ARCOS BULLITEN 2012-3

SUBJECT: IT Design

USARC G-2/6 IT Design Whitepaper

Last Updated: 26 June 2012

TER IT Racks (Typical)

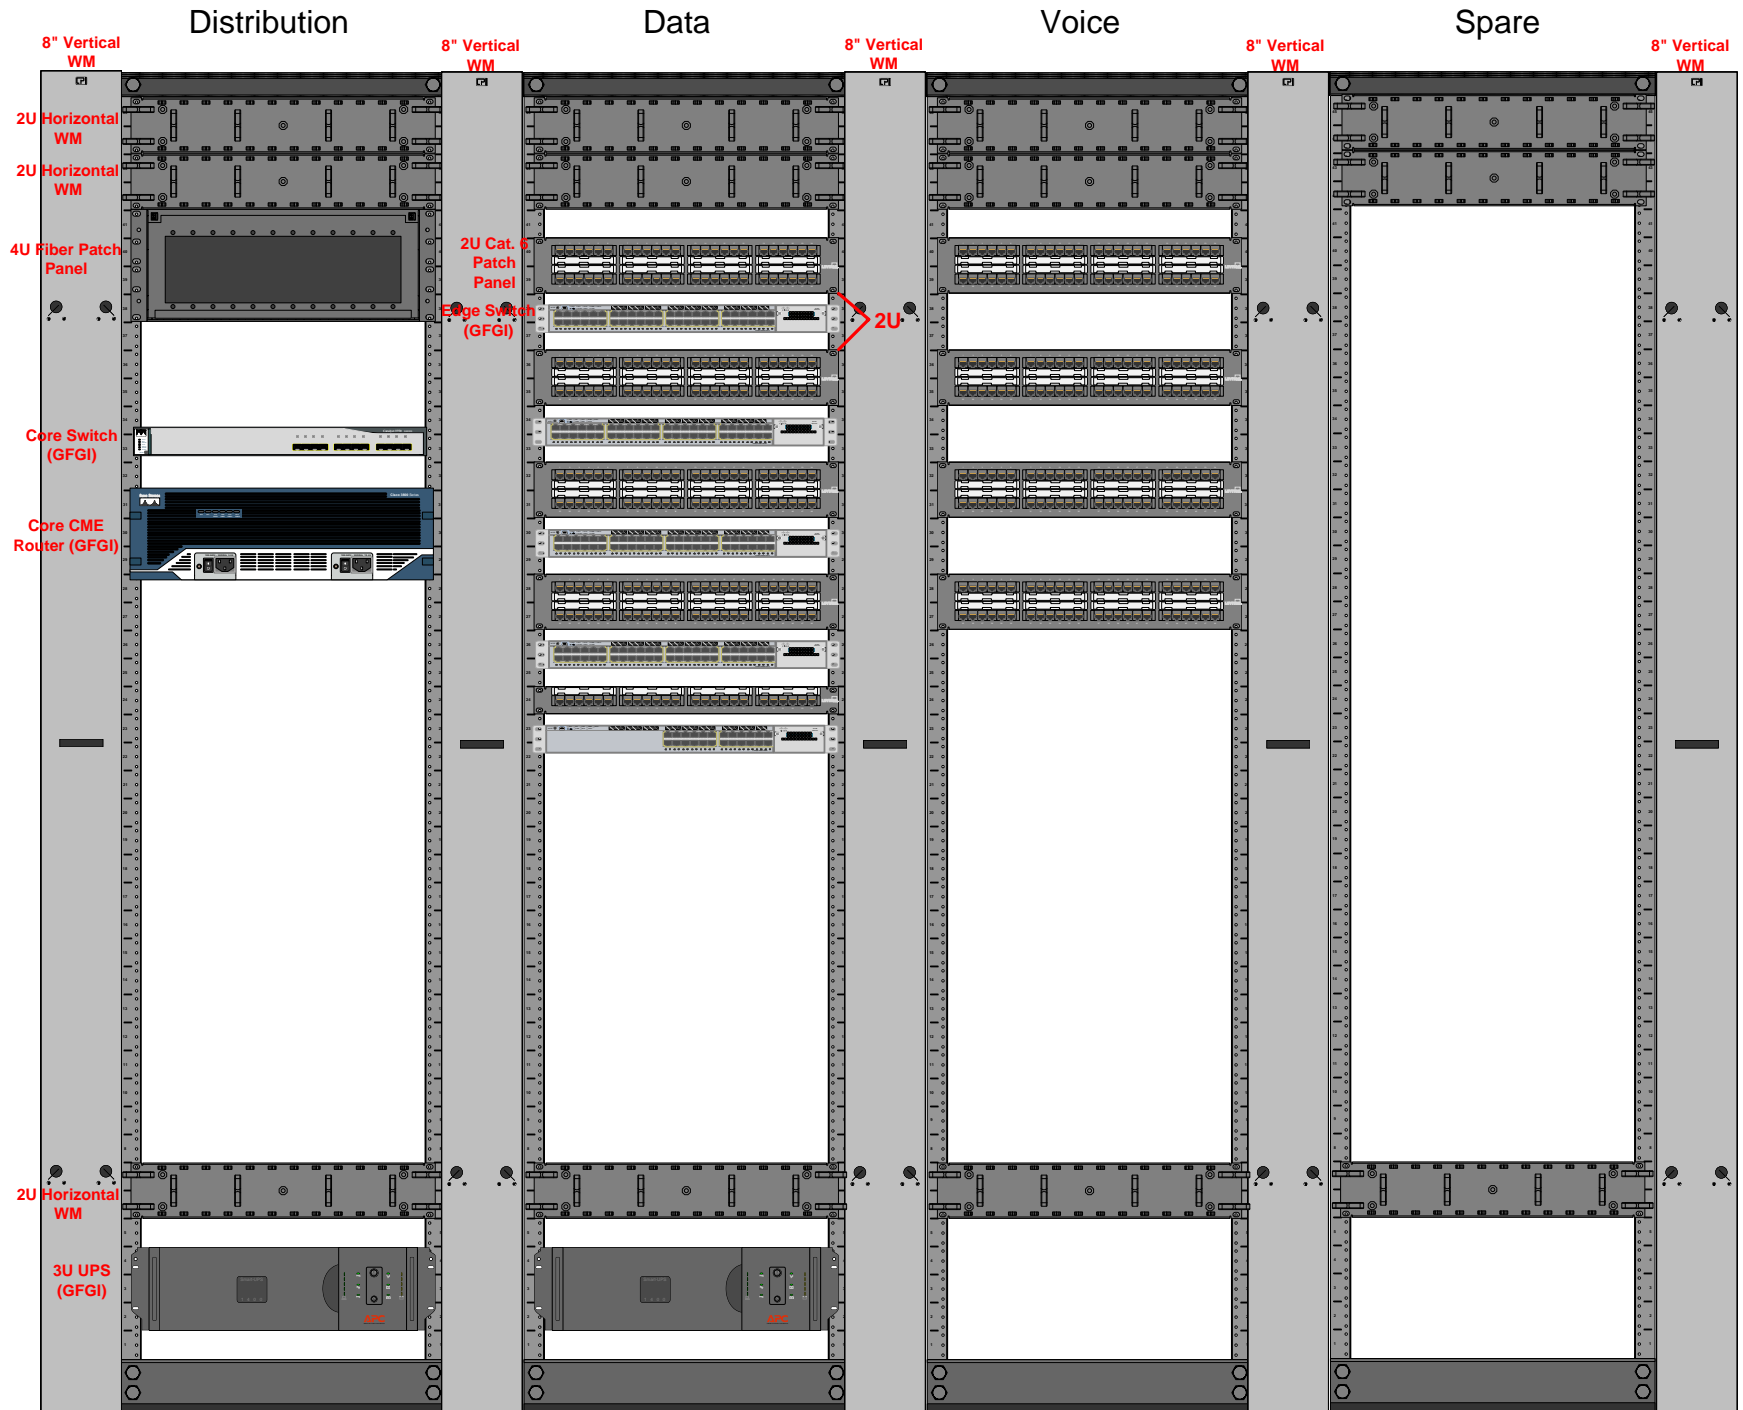
- Vertical Rack Grounding Bus-bars as defined in section 3.7.2.3 of the Army Reserve IT Manual are no longer required. All IT racks should now be grounded directly the TGB using a #6 AWG copper wire.
- GPON as defined in section 3.2.7 of the Army Reserve IT Manual should no longer be considered as an IT design alternative and this section is no longer applicable to Army Reserve MILCON projects.
